# City of Portland Design Commission

## Design Advice Request

**Date:** August 20, 2019  
**To:** Shuma Tei, Toyoko Inn Architect Co., Ltd  
**From:** Benjamin Nielsen, Design Review  
(503) 823-7812  
**Re:** EA 19-174414 DA – Toyoko Inn  
Design Advice Request Commission Summary Memo – August 1, 2019

DWG TITLE:  
**3rd AVE. Elevation**

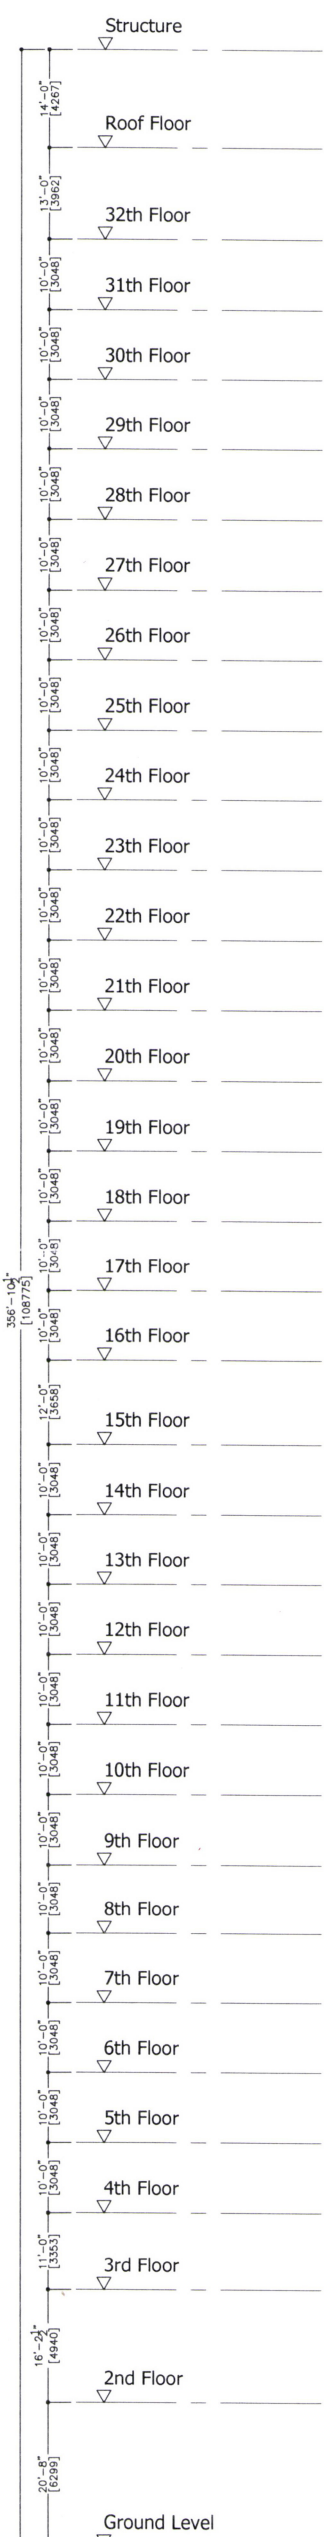
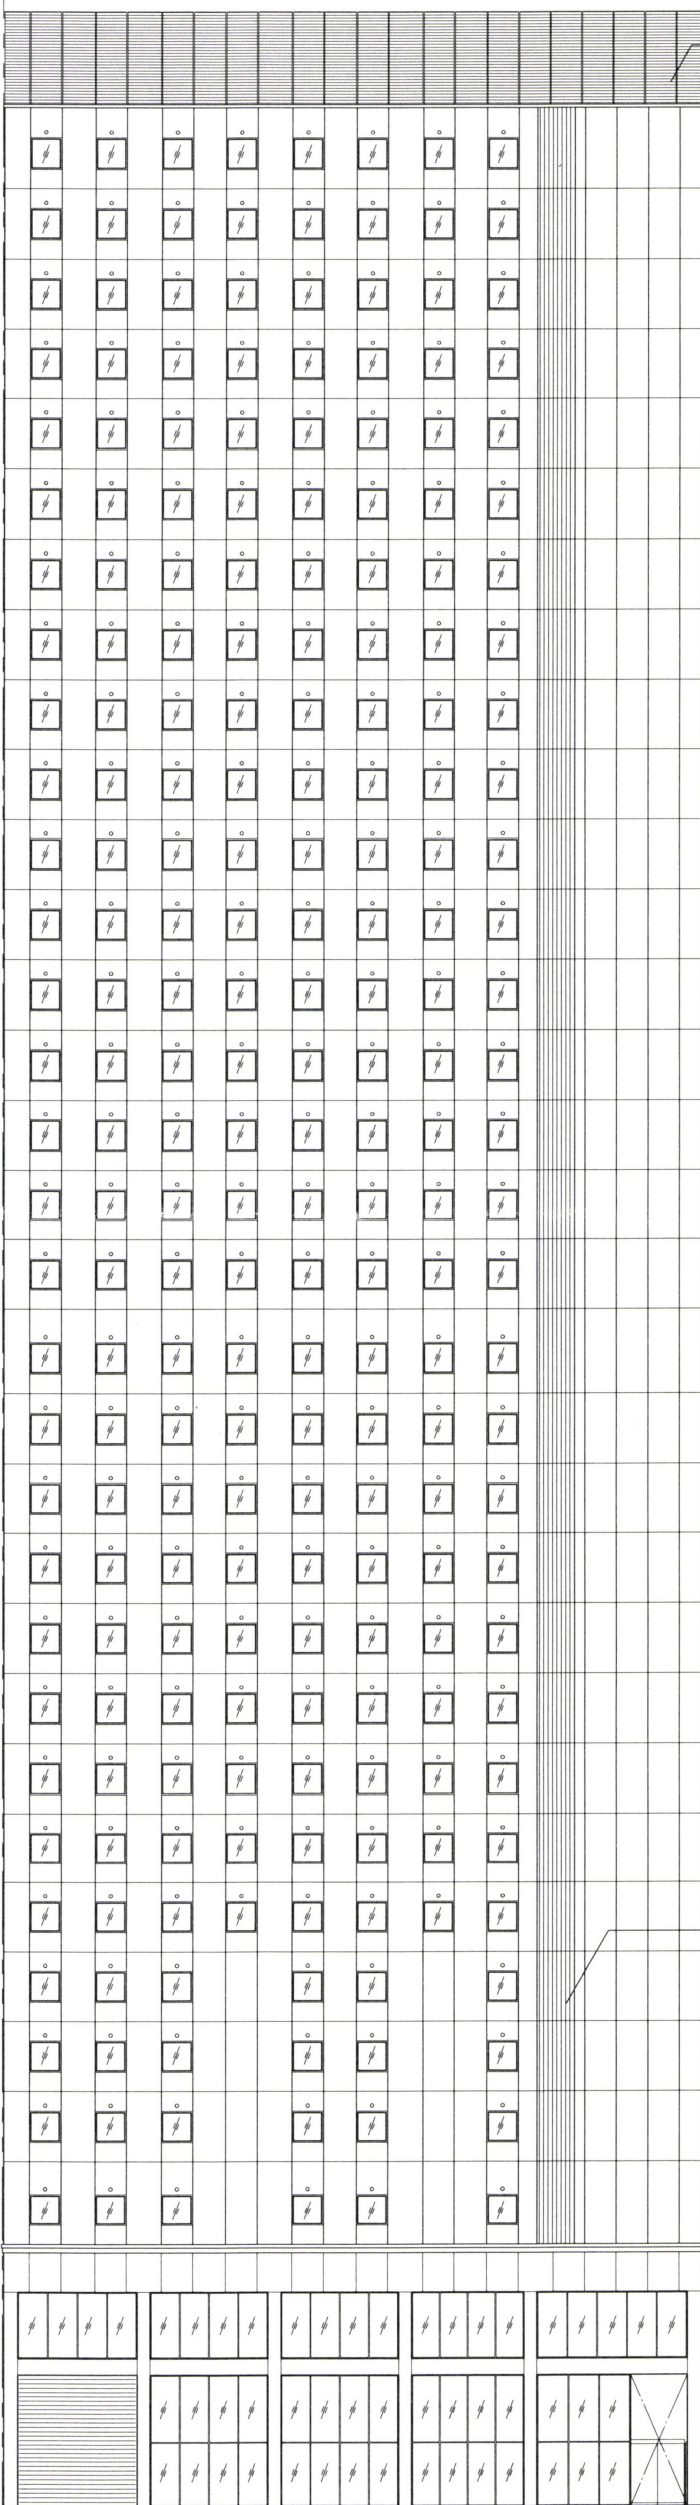
- ii. One commissioner said that the ground floor height and transparency are good, but the proportions, detailing, and the lack of canopies are not meeting the Portland scale well.

- iii. One commissioner noted that a 20-foot tall loading door seemed very out of scale for the area and the Central City, as a whole.
  - b. Commissioners said that the proportion of window openings to wall area on the tower were too low should be higher to better complement the context of existing buildings, which tend to have more window area on the upper stories. Commissioners also said the windows on the proposed hotel tower are too small as compared to windows on nearby buildings.

1. Commissioners agreed that the ground floor needs weather protection (i.e., cover from rain and sun) over the sidewalks along both street frontages.
2. **Site organization.**

DWG TITLE:  
**OAK ST. Elevation**

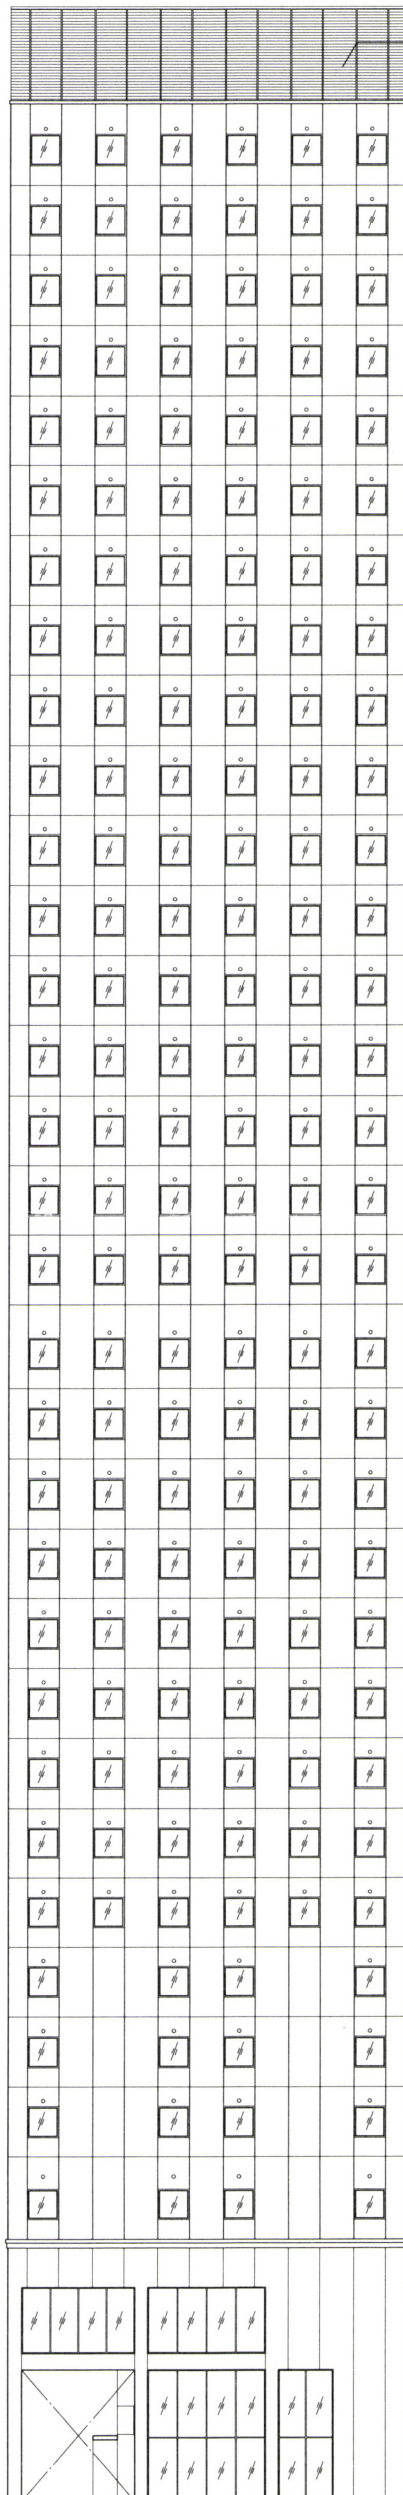
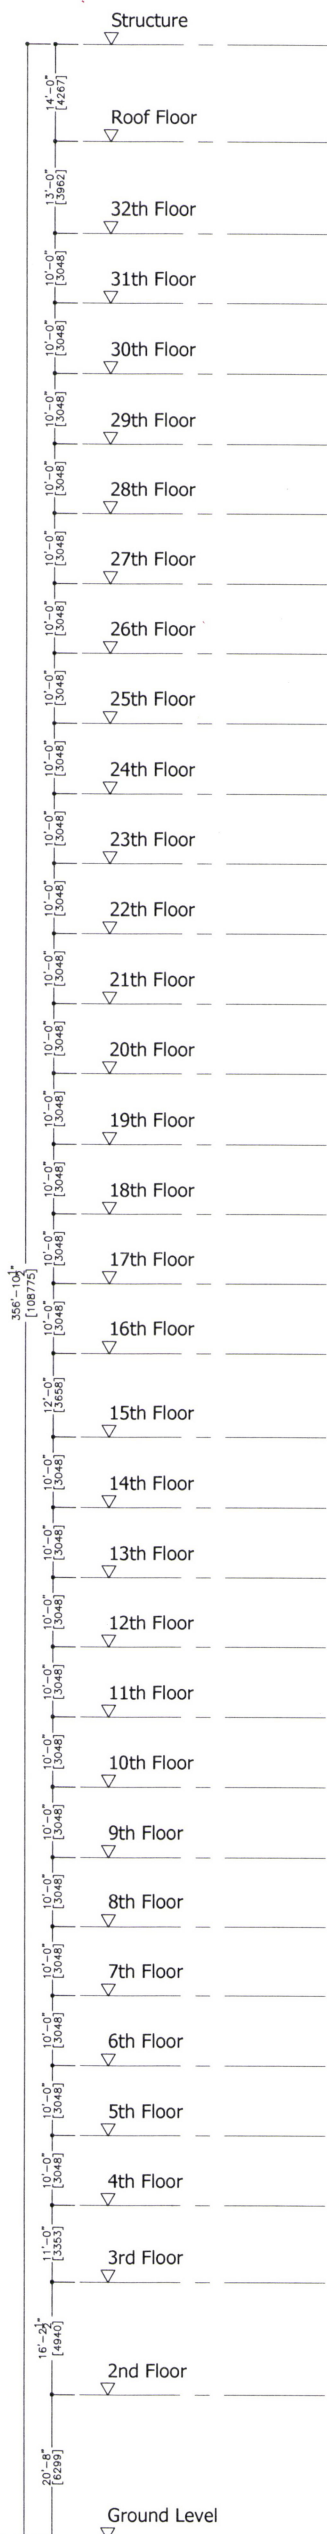
- a. Commissioners generally agreed that the proposed plaza on the east side of the hotel tower was not a contextual response.

- a. Commissioners overwhelmingly said that the proposed plaza on the east side of the site would not be successful, due to lack of activating ground floor programming on all three sides of the space. Most believe that it would be a dangerous space, and most questioned how a modification to the Required Building Lines standard (33.510.215) could be justified.

4. **Ground floor windows.** The Commission said they were not likely to support a Modification to the ground floor windows standard for the wall facing the proposed plaza. They would also not support a Modification to the standard on walls facing either SW 3<sup>rd</sup> Ave or SW Oak St.

DWG TITLE:  
**1st FLOOR PLAN**

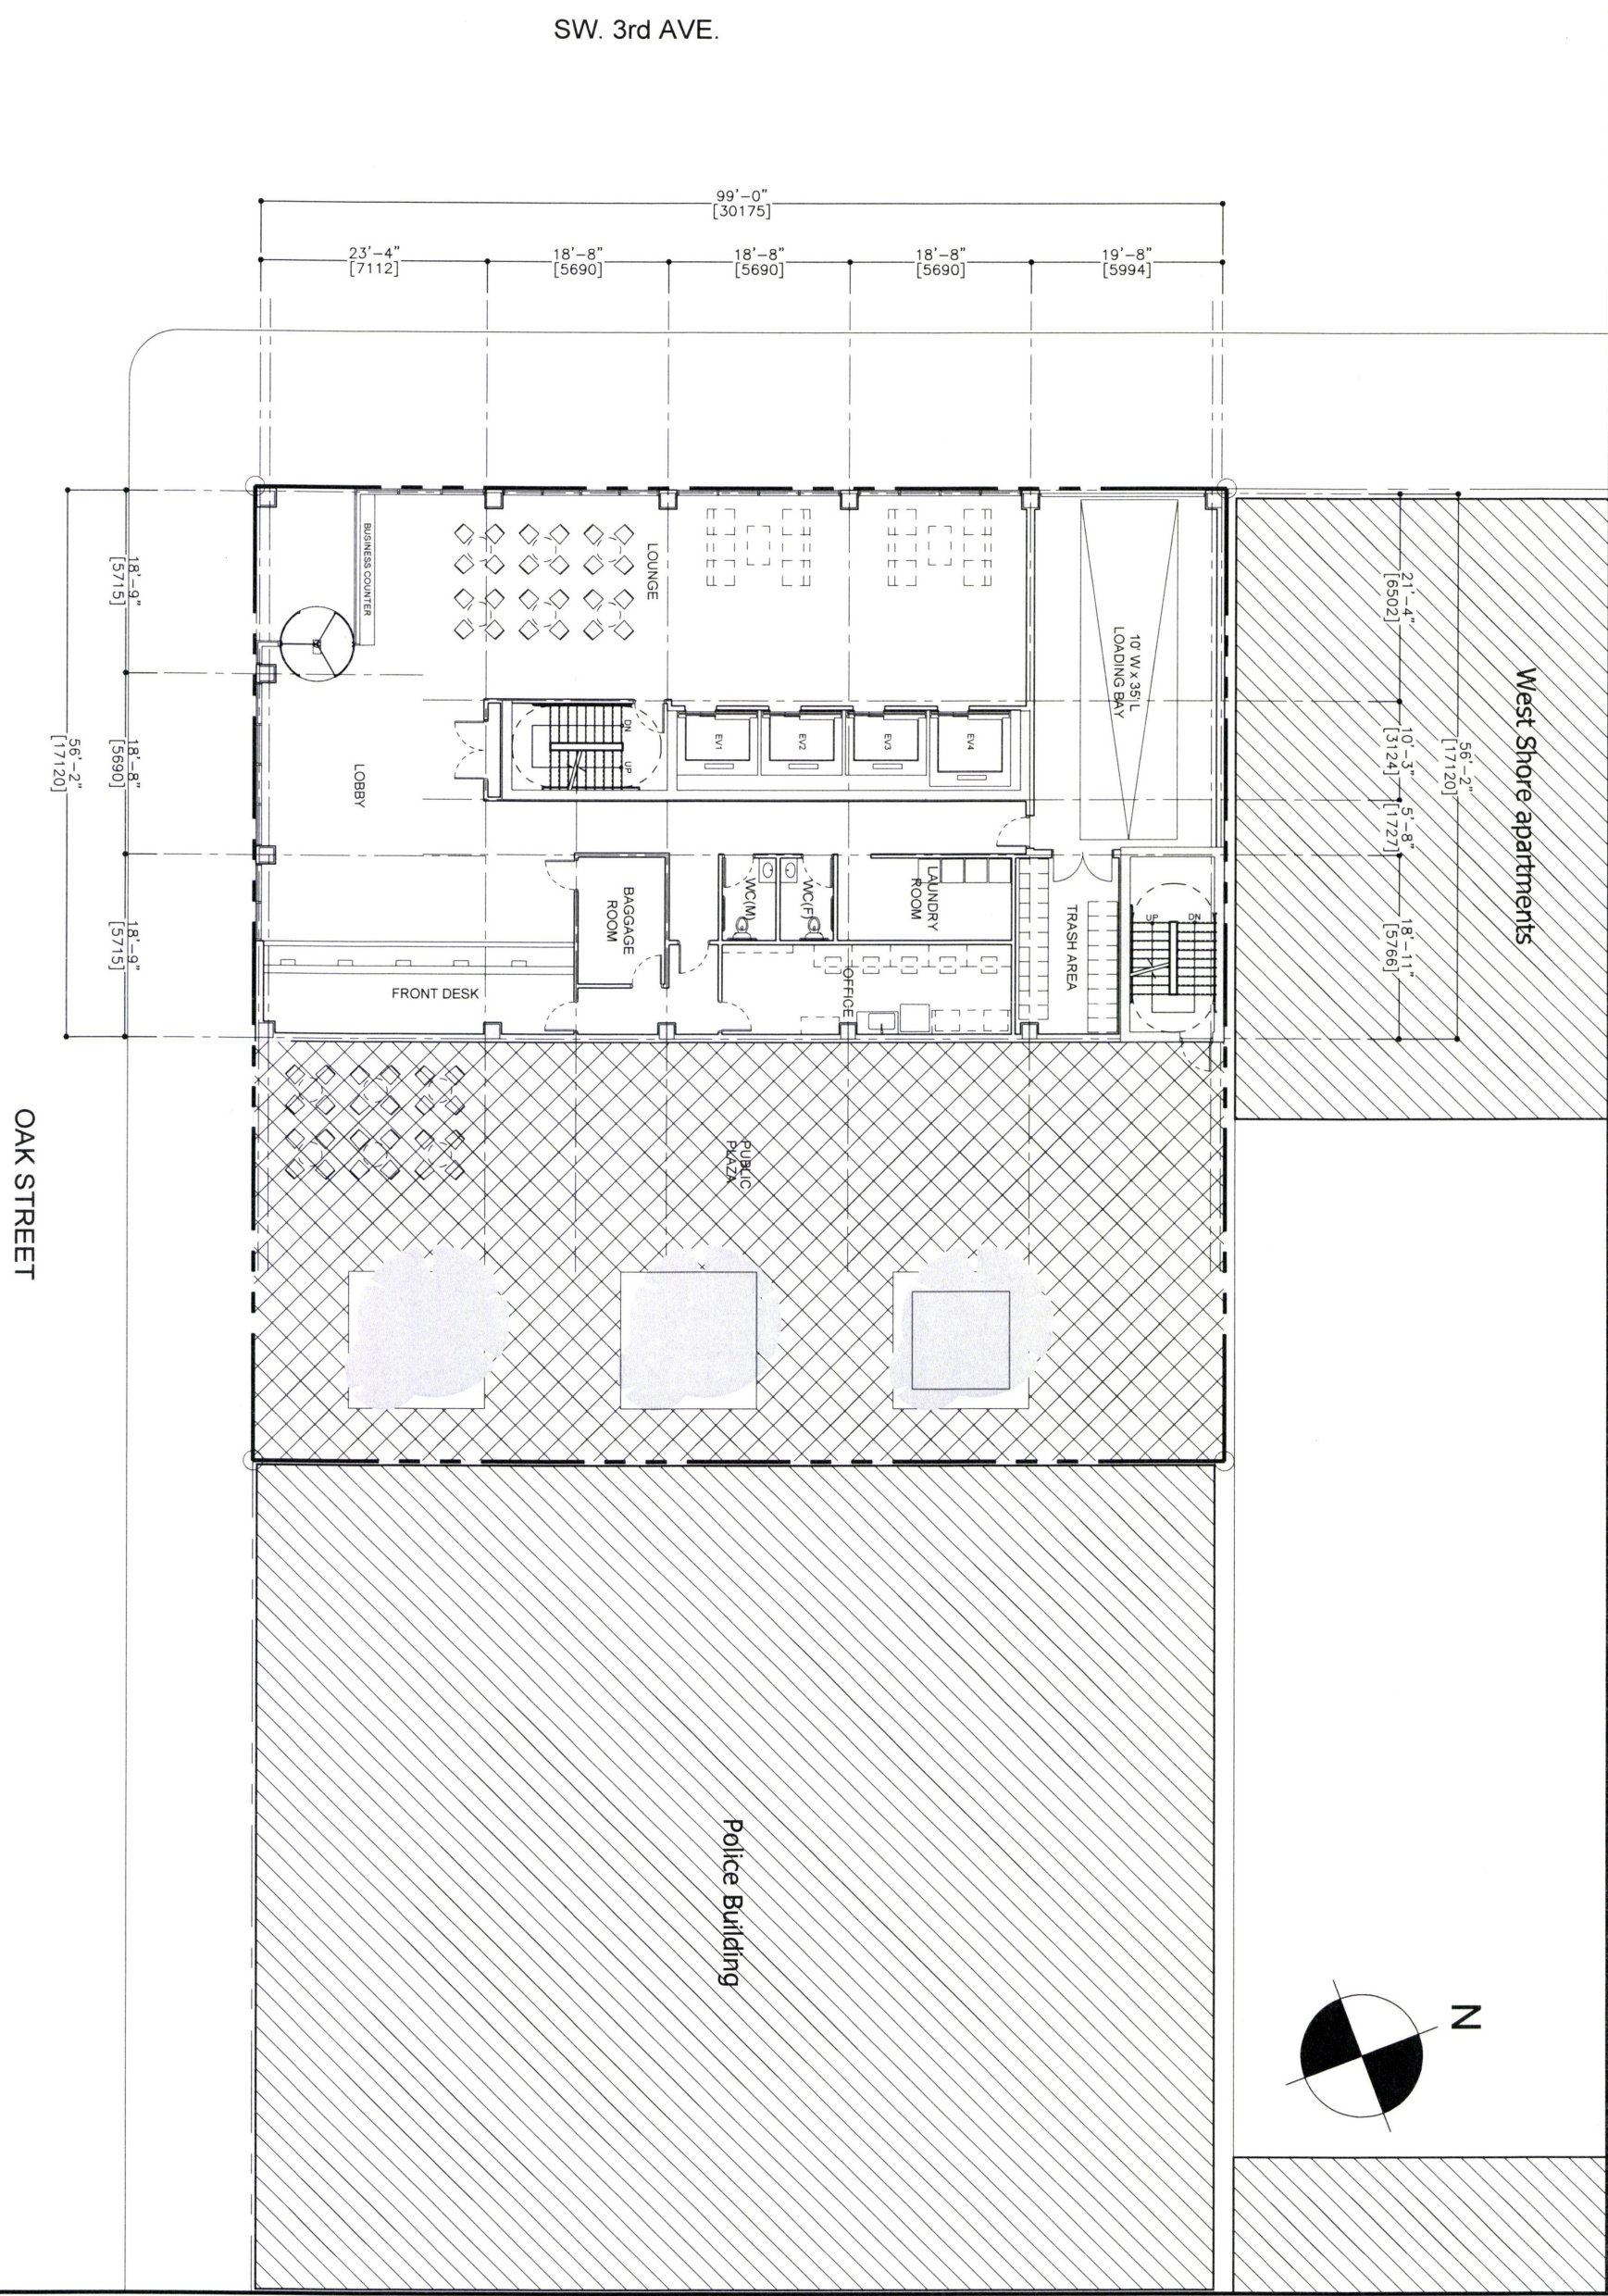
- i. Commissioners said they do not support blank walls with no windows and doors facing a plaza space or any of the street frontages.
  - b. One commissioner noted that the ground floor would be better activated and more open to the lobby if the ground floor plate were larger. This would allow an opportunity to push the elevators farther towards the middle of the block to create more space at the street edges.

4. **Entry location.**
  - a. Commissioners discussed the proposed corner entry and said that the existing, deep recess was not successfully activating the corner. They agreed that a recessed corner is neither the right design solution to create an active corner nor the right response to the historic landmark context of surrounding buildings.

- ii. Regarding the wall along the Business Counter, commissioners said that it is important that the wall be glazed rather than opaque to better activate the sidewalk and the entry.
